CONTRACT SANRAL N002-240-2018/1

**UPGRADE TO NATIONAL ROUTE N2, SECTION 24
AND SECTION 25 BETWEEN MOSS KOLNIK
INTERCHANGE (KM 21) AND UMLAAS CANAL (KM
2.7)**

ADDENDUM NO. 5

20 OCTOBER 2023

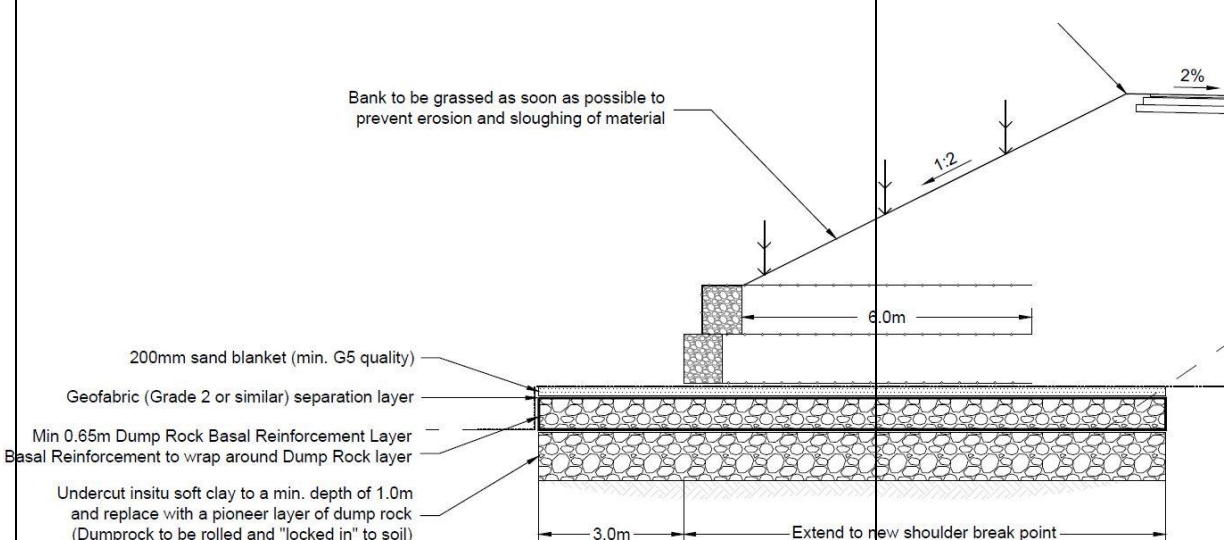
C12.6 MECHANICALLY STABILISED EARTH AND GABIONS

- C12.6/PC13.1.33 Supply and install galfan coated hexagonal woven wire mesh for basal reinforcements
 - Change quantity from 333200 to 166600.
